SUBJECT: Forwards response to request for addl info re GL 87-02, suppl  
 1, re resolution of USI A-46.

Re: Oconee Nuclear Station, Units 1, 2, and 3  
Docket Nos. 50-269, 50-270, 50-287  
License Nos. DPR 38, 47, 55  
Response to Supplement 1 to Generic  
Letter 87-02 on SQUG Resolution of USI A-46

## RESPONSE TO NRC'S REQUEST FOR ADDITIONAL INFORMATION

Scaled El Centro May 1940 Ground Response Spectrum Comparison to Oconee Required  
Response Spectrum (5% damping)

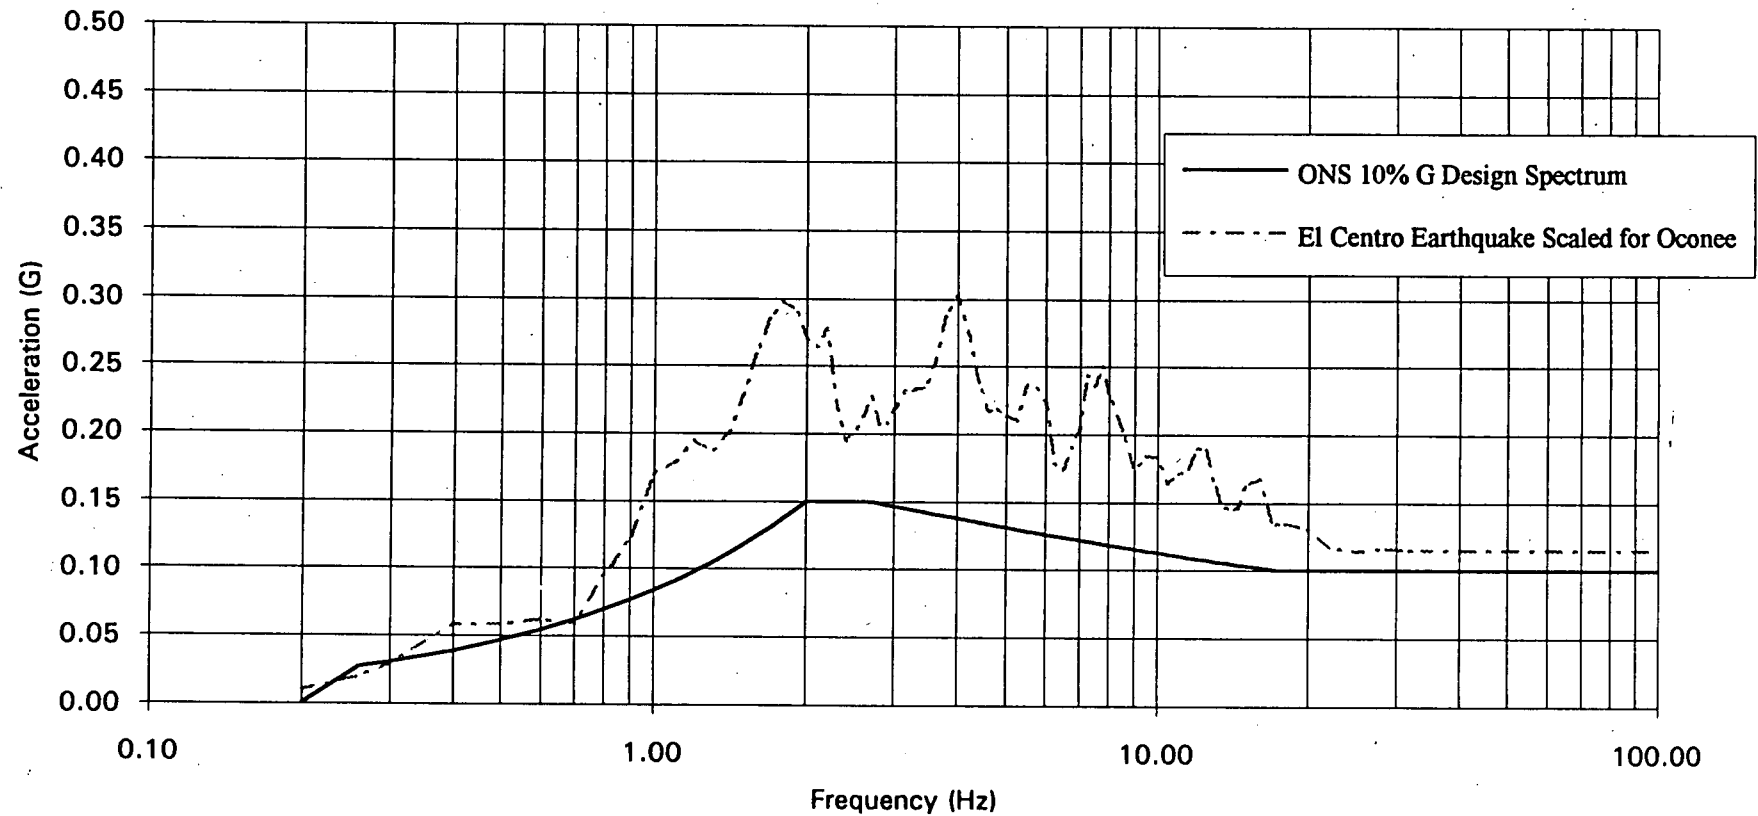
4. Question: Provide a discussion of the conservatism associated with the time history input by comparing its spectra with the original spectra.

Response: A plot of the scaled El Centro time history spectrum used for generation of in-structure spectra compared with the original design spectrum is shown on Attachment 3. The magnitude of the margin between the scaled El Centro Spectrum and the Design Ground Spectrum is a source of significant conservatism in the in-structure response spectra.
